The PV logger comm fail: what the controller does today, and the small change that stops it

Erbil plant, InteliNeo 5500 master, PLC sheet 10. Written from the archive and history exported on 14 October 2026.

Sheet 10 after the change

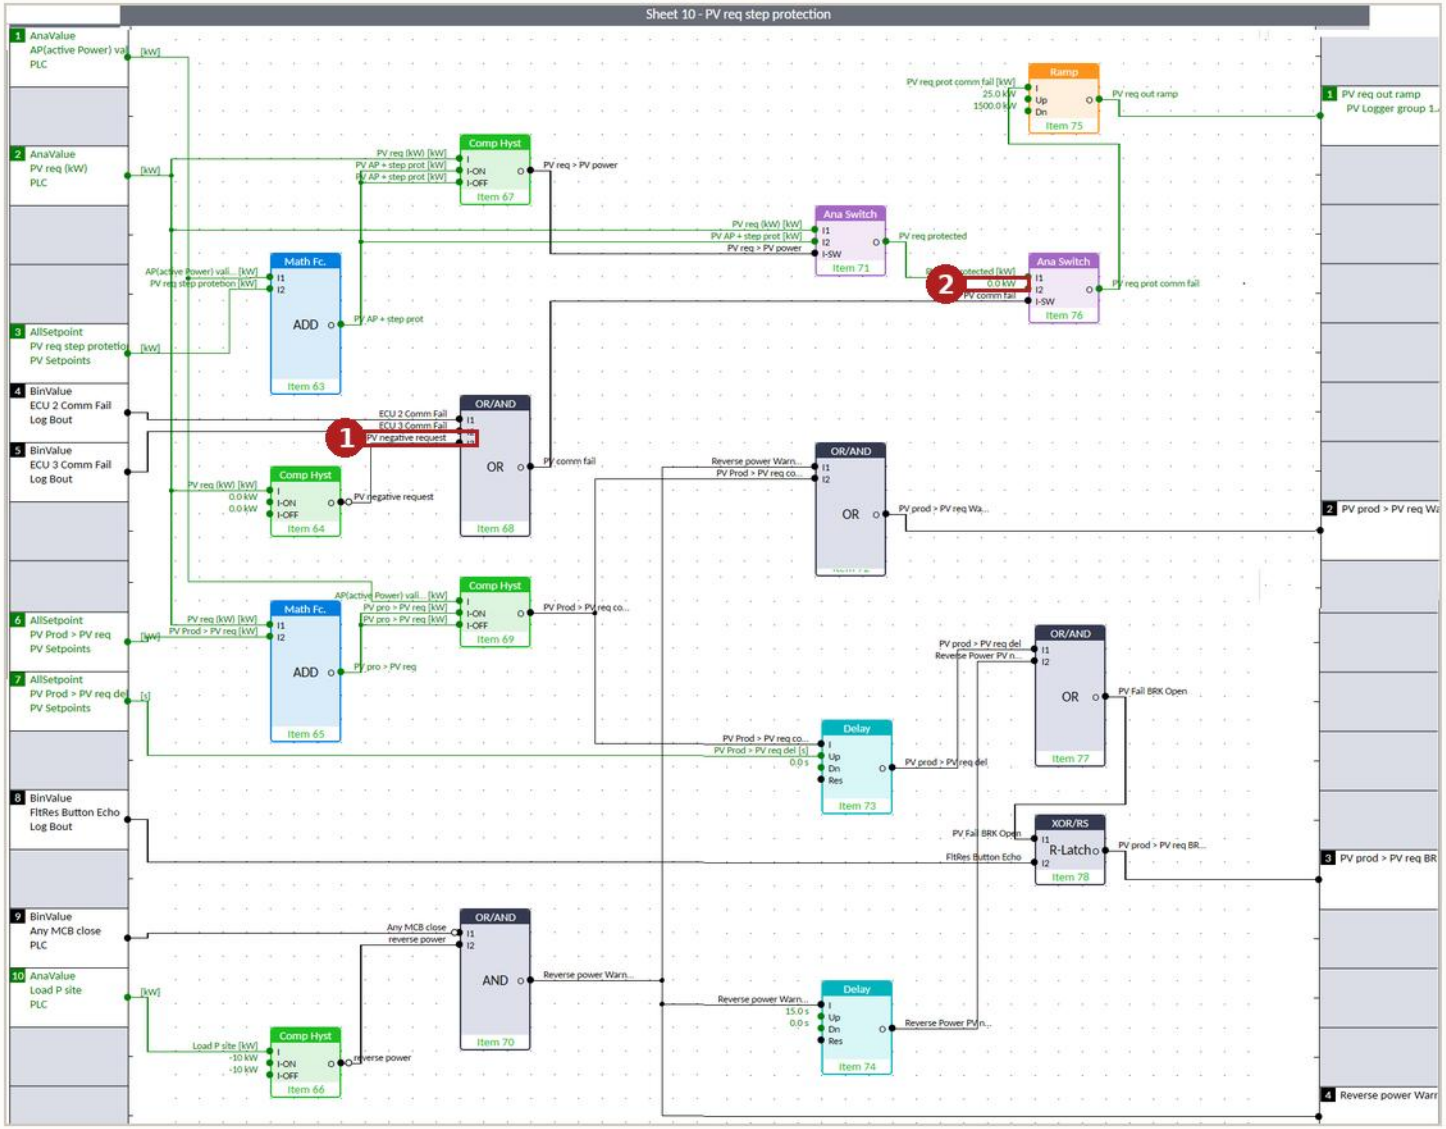
1. Item 68 now reacts only to the two real signals, ECU 2 and ECU 3 comm fail. The third input is gone.

2. The same switch, now Item 77, has its own output on its second input. A missed reply makes it repeat the last value. The inverters see no drop, the gensets see no step.

3. Item 65 is new: a five minute timer on "PV comm fail". When it runs out it raises "PV comm lost", sheet output 5. For an alarm now; for sheet 3 later, if the plant agrees.

Sheet 10 today

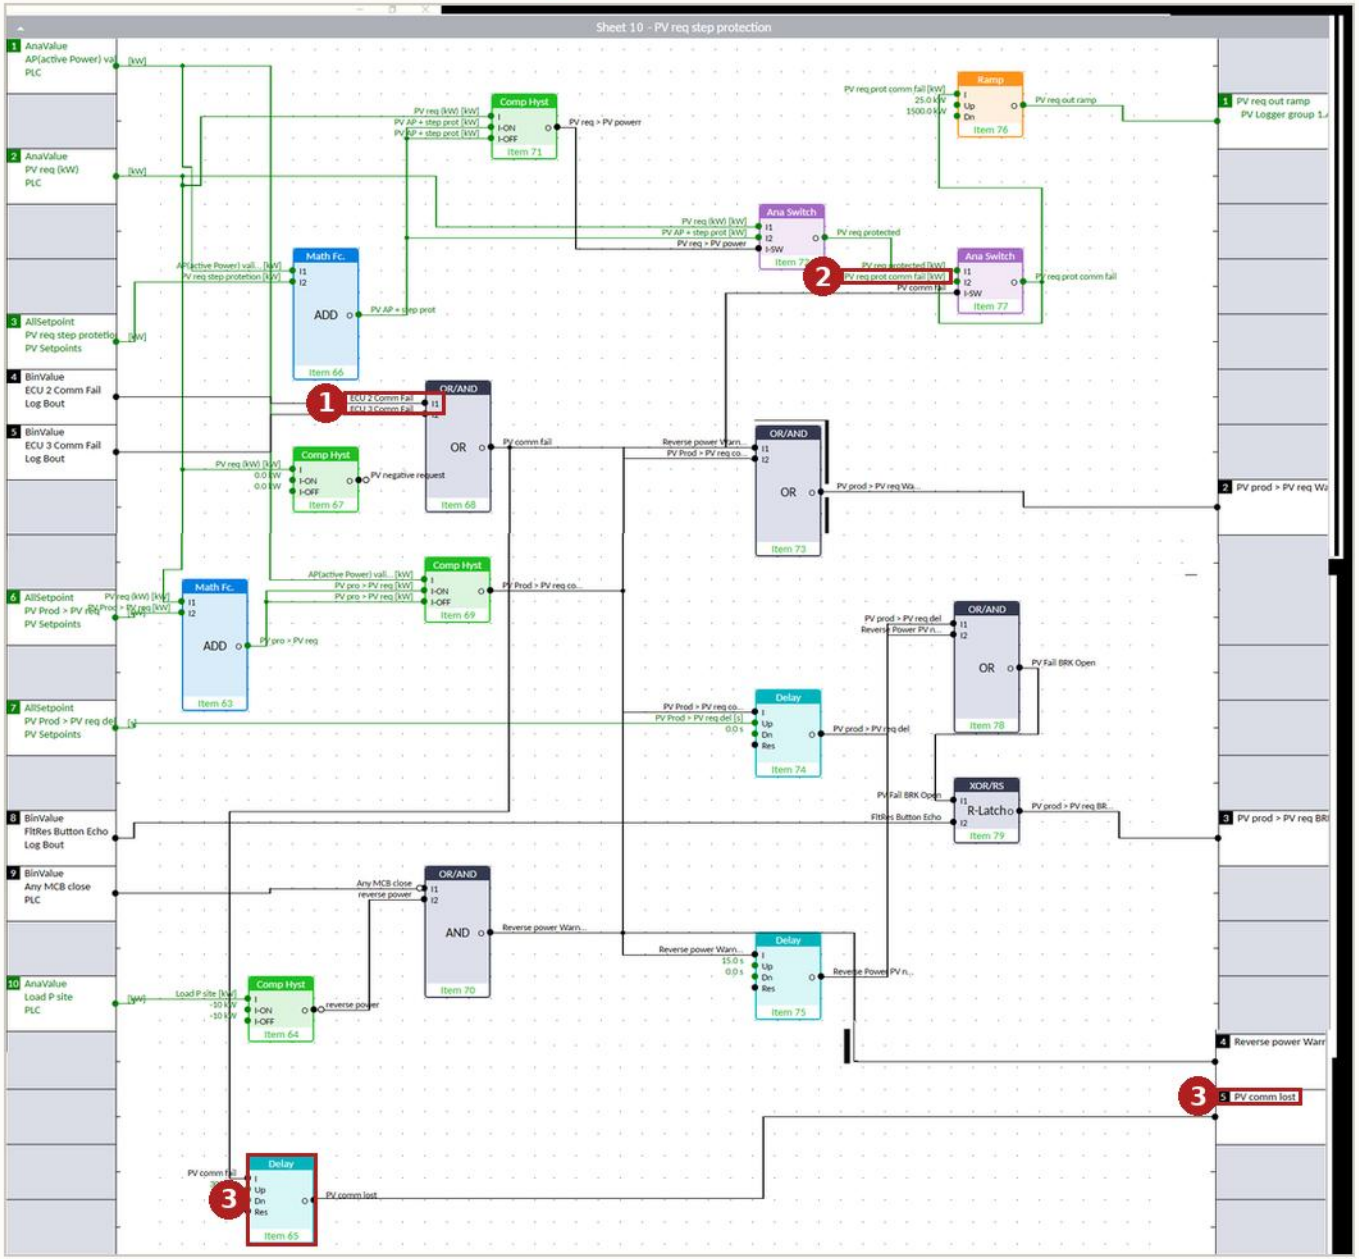
1. Item 68 decides when the request gets cut. It fires when either PV logger session misses a reply, and also when the request is zero or below.

2. Item 76 is the switch. Its second position is a fixed 0.0 kW. The moment Item 68 fires, that zero goes out to the logger, and the whole solar plant is told to stop.
